Building Addition

Kingdom Hall of Jehovah's  
Witnesses

City of Portland  
Development Review Application  
Planning Division Transmittal form

**Project Name:** Kingdom Hall  
**Address:** 355 Canco Rd.  
**Applicant:** Mark Lawrence  
**Planner:** Eric Giles

**Map 9: Proposed Travel Route**

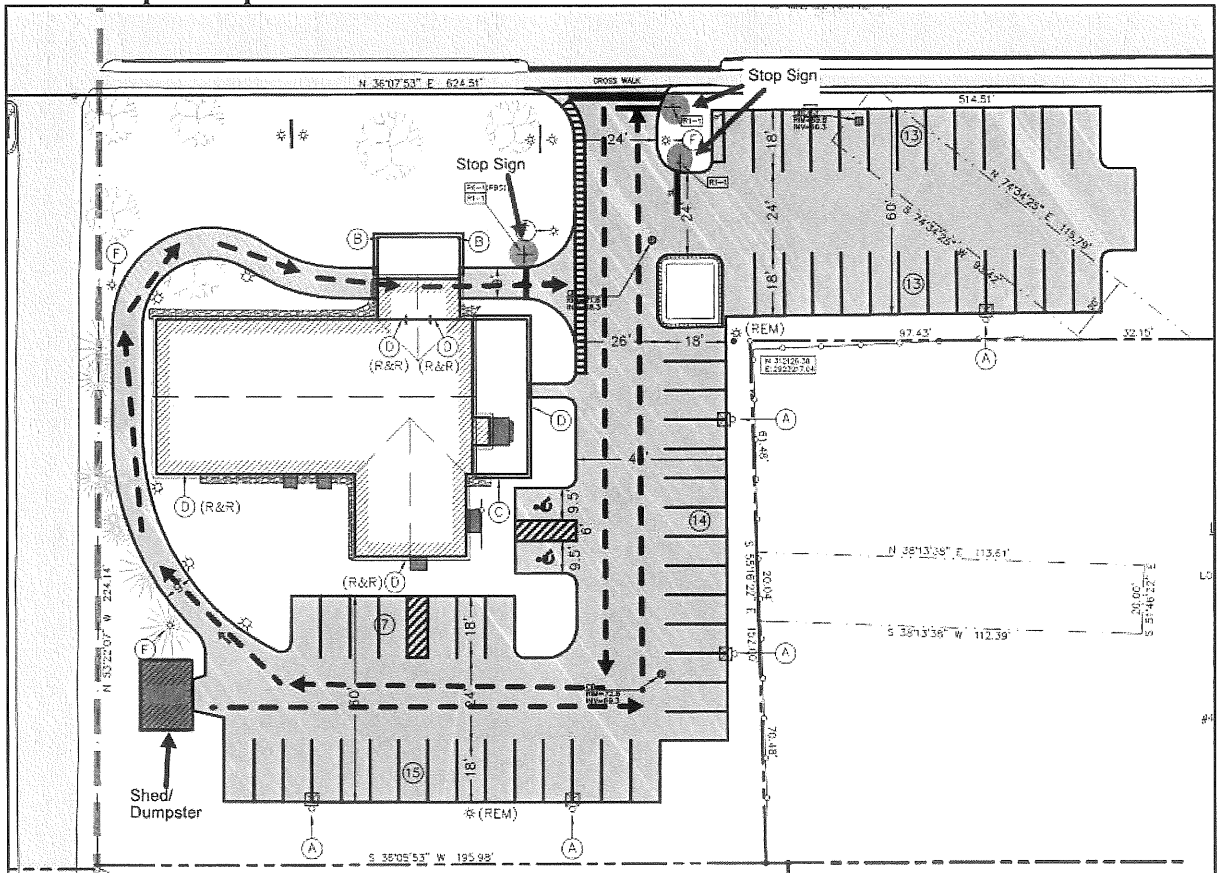
The proposed travel route as shown below, permits safe turning and backing up and does not impede site access, vehicle circulation, pedestrian movement or parking.

**Map 11: Parking Layout**

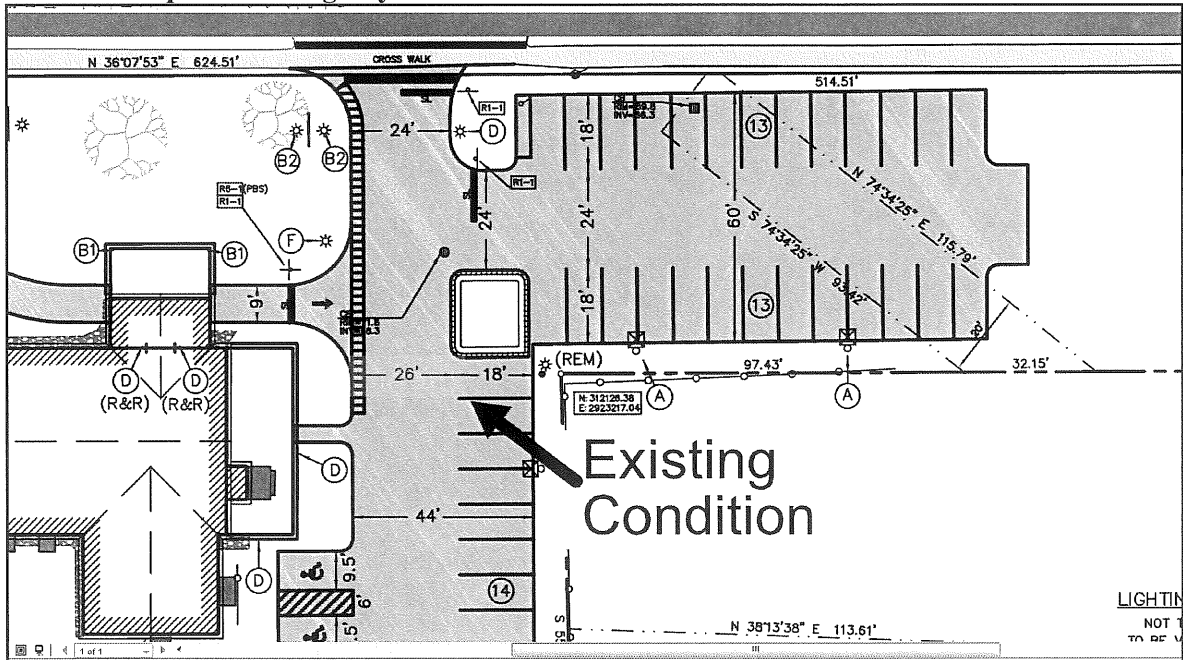
All parking stalls are meeting the minimum 9'x18' standard parking stall size. The driveway aisle width of 26' which does not meet the minimum 24' standard appears to be an existing condition. Therefore a waiver is required for the parking aisle width size, which is supported by Tom Errico since it is an existing situation (Attachment 2)

**Map 14: Drive-thru Tree Removal**

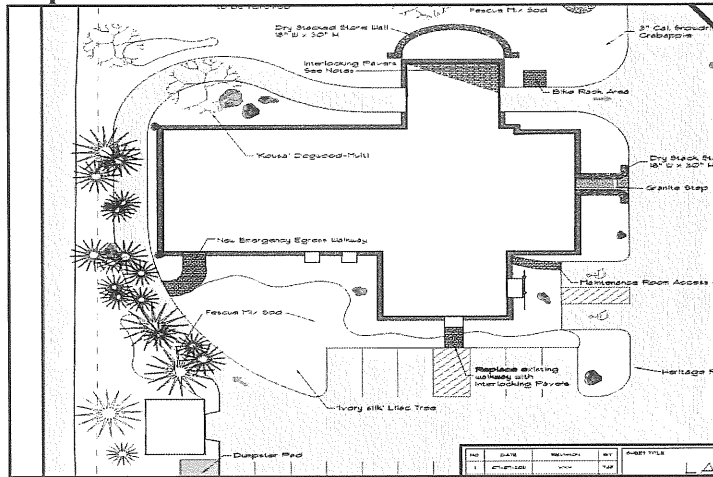
The City Arborist has identified the white pines around the drive-thru roadway will be impacted from construction. The City Arborist supports efforts to retain the trees with the reduced driveway width and protection during construction. It should be noted that the Tree Removal plan shows this area of white pines will be cleared entirely see Map 14.

If this entire area is to be cleared then the Tom Errico, Traffic Engineer, will require the roadway to be built with a minimum 12' wide aisle width rather than the 9 feet. Mr. Errico's comments (Attachment 2) are as follows:

**Map 17: Landscaped Island in Parking Lot**

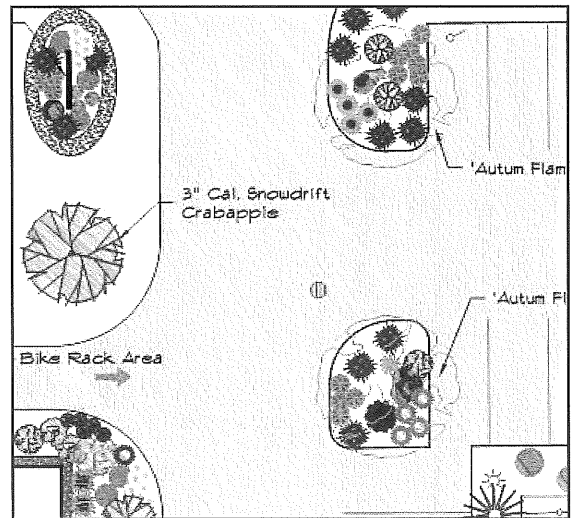
One island is shown in the parking lot that will include landscaping. The Parking and Utility plan appears to show this island with curbing.

**Map 18: Stormwater Management Plan**

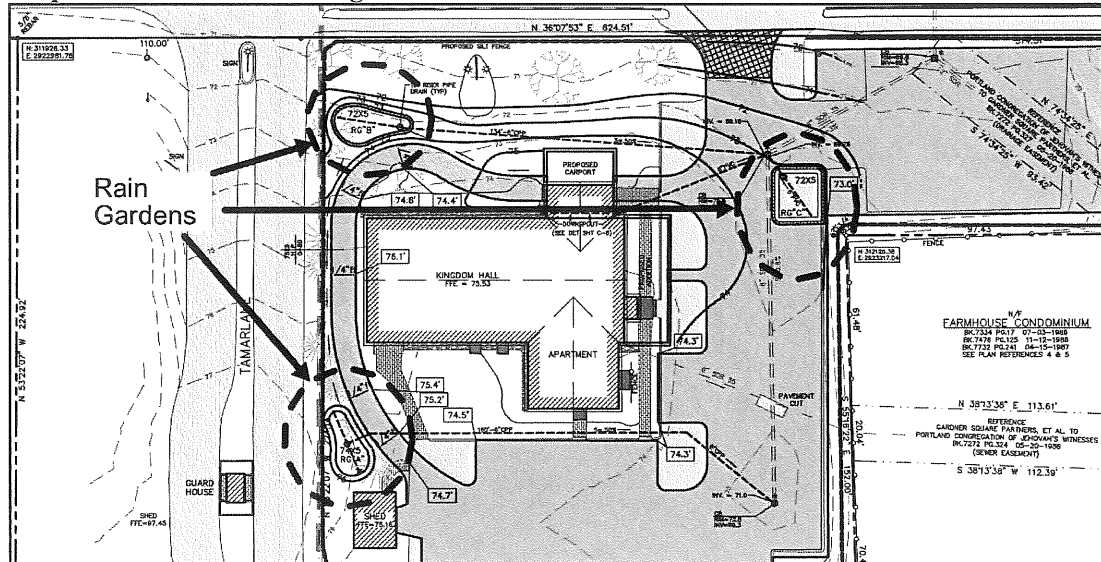
The proposed site plan is located within the Fall Brook Watershed Urban Impaired Stream. The stormwater management plan must also comply with the basic, general, and flooding standards of Section 5 of the Technical manual. The Grading, Drainage, and Erosion Control plan shows three (3) new rain gardens to be installed on the site to accommodate increased stormwater flows and water quality treatment meeting the Urban Impaired Stream Standards.

According to David Senus Stormwater Engineer, the proposed stormwater system will meet the technical requirements of Section 5, with adjustments to the underdrain soil filter in Rain Garden A. As a condition of approval the applicant should revise the construction detail prior to issuance of a building permit.

5. Prior to issuance of a Building Permit the applicant shall revise the Grading, Drainage, and Erosion Control plan to meet the review memo of the Stormwater Engineer dated 8.17.2011.
